**Parks Canada  
La Mauricie National Park**

Addendum n° 1

**Replacement of 20 Wastewater Treatment Systems  
Phase 1 – 5P301-14-0002**

Project n° 630573  
September 16 2015

## ÉLÉVATION

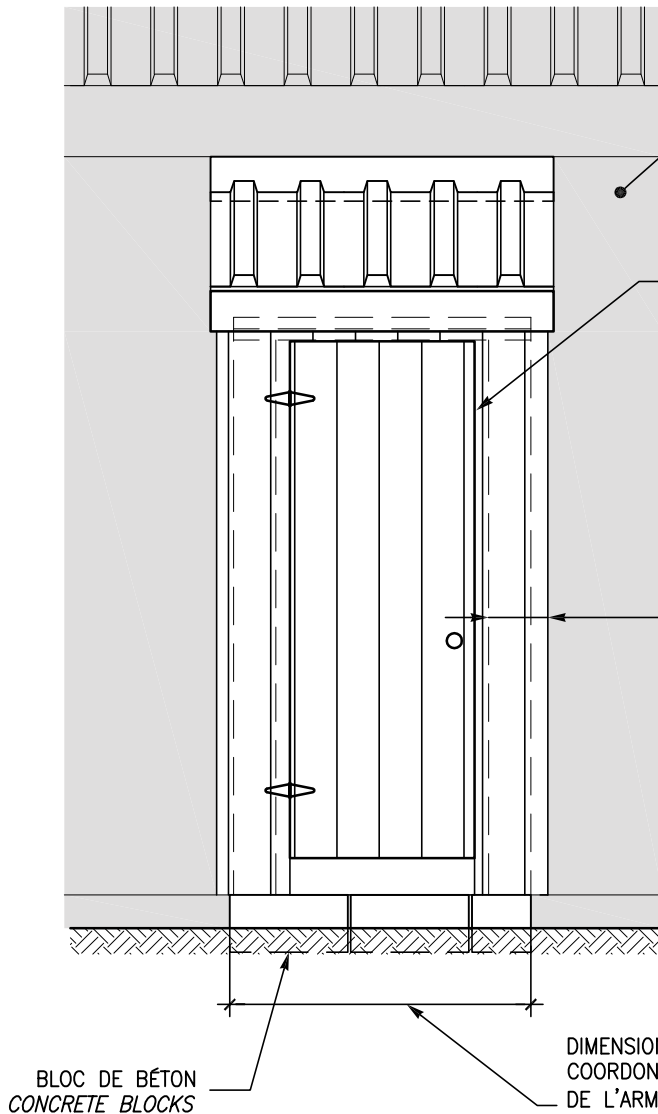
LA PORTE D'ACCÈS DE L'ARMOIRE DE BOIS DOIT PERMETTRE UNE PLEINE OUVERTURE DE LA PORTE DE L'ARMOIRE D'ÉQUIPEMENTS  
ACCESS DOOR OF THE CABINET MUST ALLOW FULL OPENING OF THE ACCESS DOOR OF THE EQUIPMENTS CABINET

- 38x140 TRAITÉ @ 400mm MAX.
- CONTREPLAQUÉ OU OSB 16mm
- LATTAGE HORIZONTAL 19x64mm @ 400mm
- PLANCHES DE CÈDRE DE L'OUEST PROFILÉ RANCH PANELING 1"x8" #2 (FOURNISSEUR CANAC)
- FINITION # 2092-20 (SIENNE) POUR LE PRODUIT SUIVANT : ARBORCOAT, OPAQUE K640-4X (POUR FIN DE RÉFÉRENCE SEULEMENT)
- 38x140 TREATED @ 400mm MAX.
- TREATED PLYWOOD OR OSB 16mM
- HORIZONTAL LATTING 19x64mm @ 400mm
- CEDAR WOOD PANEL PROFILE RANCH PANELING 1"x8" #2 (SUPPLIER CANAC)
- FINISH # 2092-20 (SIENNE) FOR THIS PRODUCT : ARBORCOAT, OPAQUE K640-4X (FOR REFERENCE USE ONLY)
